## TECHNICAL BULLETIN — No. 07-09-1544 CSA/CEC SECONDARY PROCESS SEAL APPROVAL FOR MODEL 7800 & 7850 I/P TRANSDUCERS

October 22, 2007

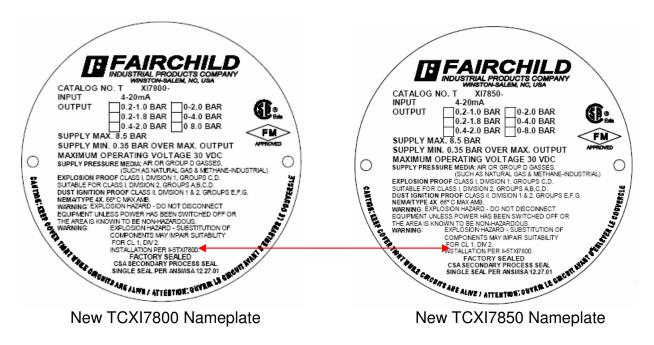
Fairchild is changing the nameplates of the TCXI7800 and TCXI7850 to show full compliance and CSA approval. The drawings below depict the new label nameplate which will be available soon.

As shown above, the lower portion of the nameplate will indicate the CSA Secondary Process Seal approval and the ANSI/ISA spec level. The units retain the "Factory Sealed "certification. When available, these new nameplates will be used for every CSA approved TCXI transducer manufactured at Fairchild. In the interim, Fairchild has obtained permission from CSA to apply a sticker to each model TCXI7800 and TCXI7850 product to designate compliance with the new Secondary Seal Approval level. The sticker will include all pertinent CSA information, in the configuration depicted below:

CSA
SECONDARY
PROCESS SEAL Single Seal
Approval
per ANSI/ISA
12.27.01:2003

This sticker will be used for existing finished goods inventory as well as all new production until the new nameplates are available.
